14 July 2021

The National Trust raise serious concerns regarding modification (SSD-10340-Mod-1) which increases the height and bulk of the Fort Street Public School. The proposal goes against all previous planning and heritage advice for this State Heritage Listed location, and is now actively ignoring all submission responses – 99% of which opposed the modification.

Appendix: National Trust concerns raised in our submission opposing modification (SSD-10340-Mod-1)

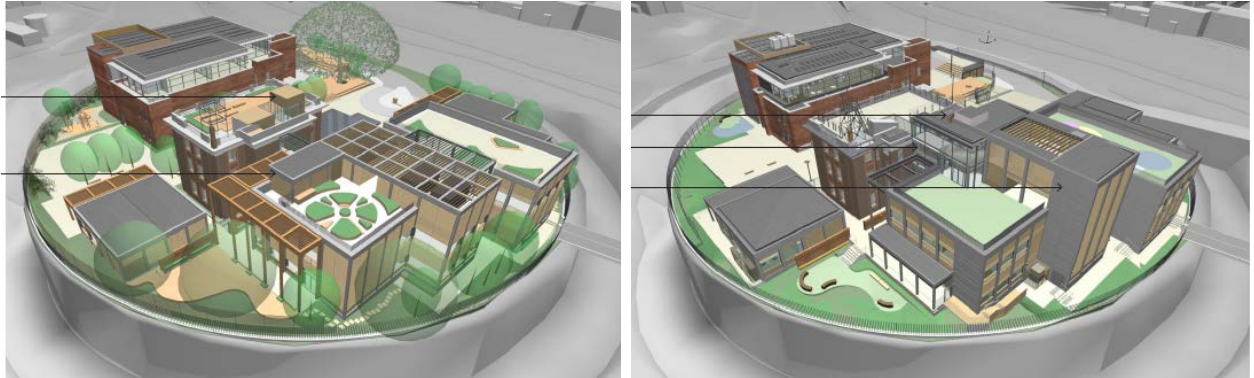
- a major redesign of the main new building on the site;
- increasing Building J by an additional level;
- removing an entire lower ground floor level;
- modifying all building services including lifts and mechanical plant;
- dramatically changing the external envelope in both design and material;
- completely altering the internal floor plan.

The new design means that a large, four-storey fire escape stair will now loom over one of Sydney's oldest public buildings (the National Trust Centre, housed within the remaining sections of the 1815 Military Hospital and 1840 National School) and be the immediate view from the main entry and exit door to the S.H. Ervin Gallery, housed within the 1856 Fort Street School building.

The approved design (left) and the "modified" design (right). Given the sensitive location, and the relatively small scale of the works under discussion and their impact on adjacent heritage buildings, this must not be considered a modification as per the definition under Section 4.55(2), which states that works must be "substantially the same" for which consent was originally granted. (Source: FJMT Architectural Design Statement, pp.29-30)

The original design (above) with classrooms fronting the National Trust Centre, compared to the new design (below) showing the dramatically increased building form and height. (Source: Heritage Impact Statement)

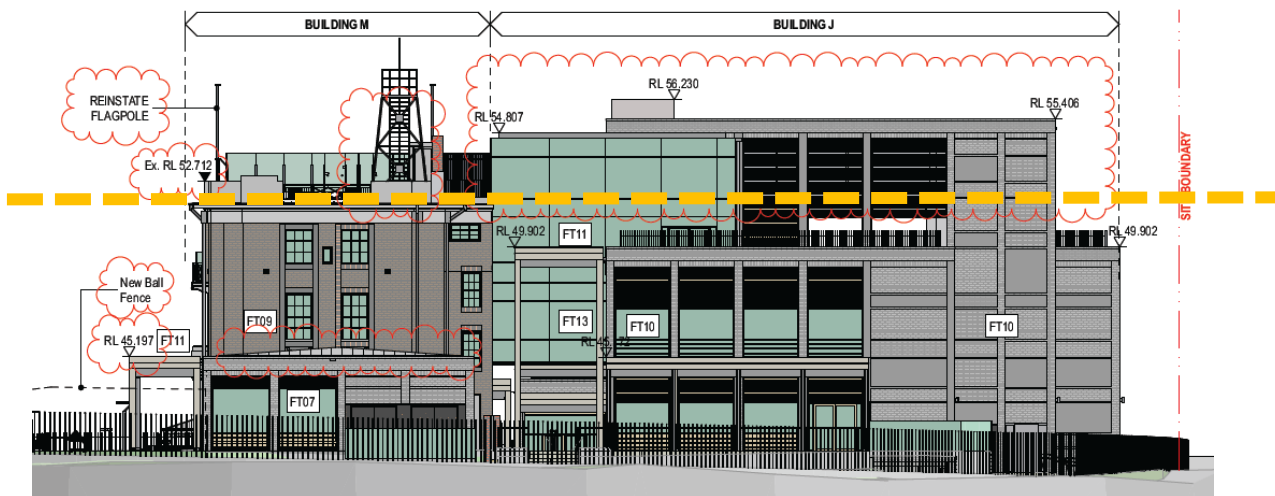
The proposed west elevation, showing the height datum of the rooftop of the MET Building and the new floor that is proposed above this line. This drawing was not included in the Heritage Impact Statement by Curio Projects that accompanied this modification. (Source: FJMT drawing, with National Trust overlay)
